## DSA CODE AMENDMENT DEVELOPMENT

Applicable Code Section(s): CBC, Chapter 2 Definitions

Topic: Multi-bedroom Housing Unit

**FIGURE 11B-809.8.3.1 (3) FIGURE 11B-809.8 Ex. 1(c)**  
**PLATFORM AT SECONDARY EXTERIOR DOOR**

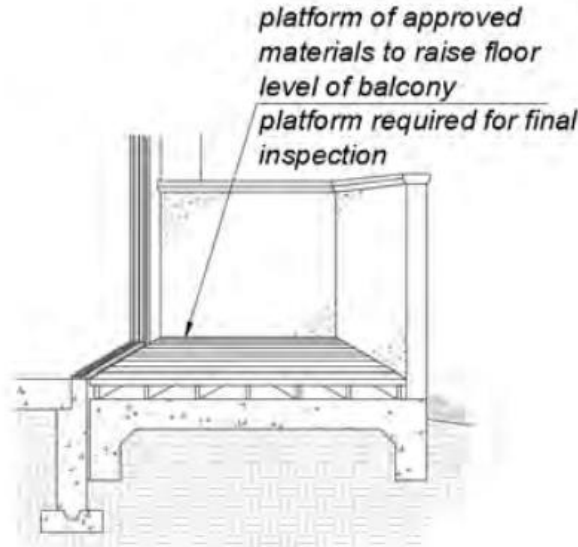
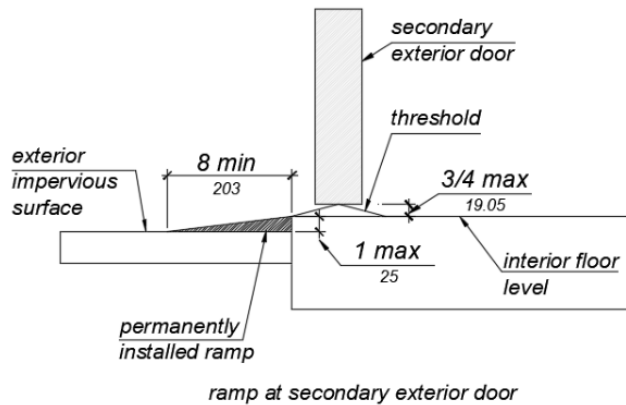
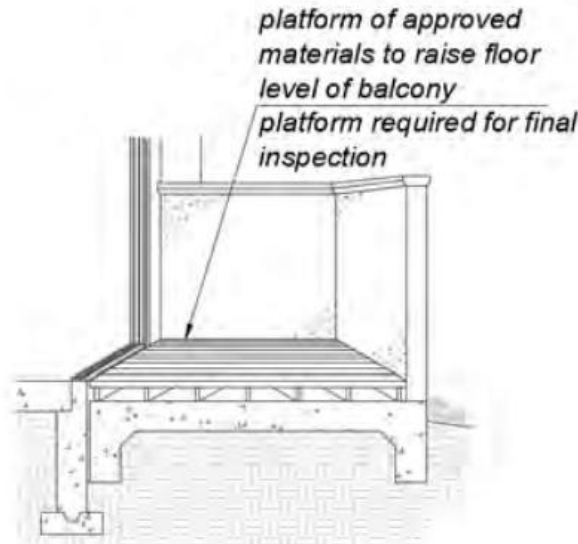
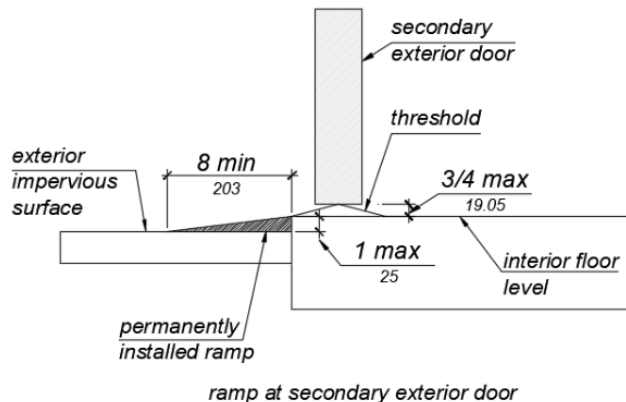
DSA proposes to amend the requirements of 11B-809.8 to provide clarity for interior doors within residential dwelling units with adaptable features. Existing language in the code required interior doors to comply with Section 11B-404.2, yet subsequent requirements in the section provided a list of specific requirements for interior doors that conflicted with Section 11B-404.2 and created an invalid exception to the requirements. Conflicting requirements are a violation of Health and Safety Code 18930(a)(1), also known as item one of the nine-point criteria for building standards. This created confusion to the code user. The proposed language lists the specific requirements of Section 11B-404.2 which are applicable to interior doors in residential dwelling units with adaptable features and provides greater clarity to the requirements that are specific to interior doors in residential dwelling units with adaptable features provided in Section 11B-809.8.

To further clarify the requirements, the existing exceptions in Section 11B-809.8 are proposed to move to the more appropriate location in Section 11B-809.8.3.1.

**FIGURE 11B.809.10.6.3**  
**TRANSFER TYPE SHOWER CLEARANCE**

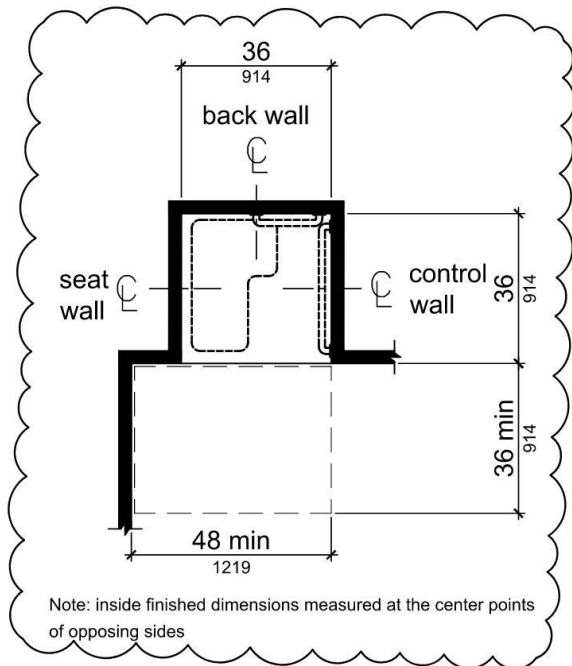
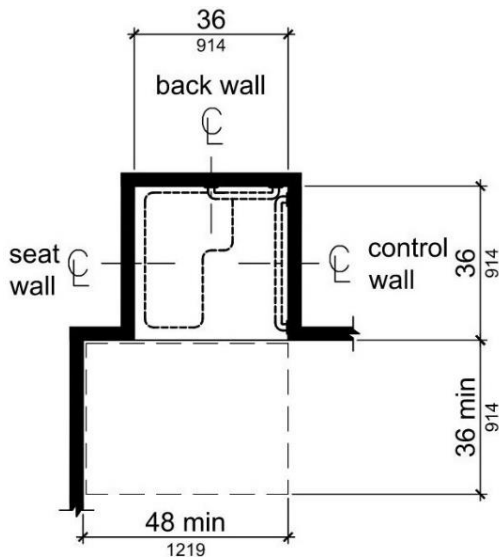
**11B-809.10.6.3 Clearance Floor space.** *A clearance of clear maneuvering space 30 inches (762 mm) 36 inches (914 mm) wide minimum by 48 inches (1219 mm) long minimum measured from in length shall be located outside the shower, with the width flush with the control wall shall be provided outside and the length parallel to the length of the shower as illustrated in Figure 11B-809.10.6.3.*

Rulemaking Cycle, DSA attempted to clarify in Section 11B-809.10.6.1 the reference to Section 11B-608.1, which specifies the size for transfer showers. In addition to the size, the reference provided for a 36" x 48" clear floor space at the shower fixture, and a subsequent reference in Section 11B-809.10.6.3 which specifies a 30" x 48" floor space, provided for conflicting requirements. While the 30" minimum clear floor space width is the minimum permitted by the Fair Housing Act, individuals with disabilities acknowledged the minimum clear floor space requirements were insufficient. The Building Standards Commission did not approve the proposal and requested that DSA provide further study. DSA advances this proposal to increase to 36" wide the clear floor space at all showers in residential dwelling units with adaptable features. A referenced figure is necessary to illustrate the position of the clear floor space relative to the control wall of the shower and ensure the ability to enforce the elements clarified in the figure. (See companion proposal for Section 11B-809.10.6.1.)

**11B-809.10.6.3 Clearance.** A clearance of 36 inches (914 mm) wide minimum by 48 inches (1219 mm) long minimum measured from the control wall shall be provided outside the shower as illustrated in Figure 11B-809.10.6.3.
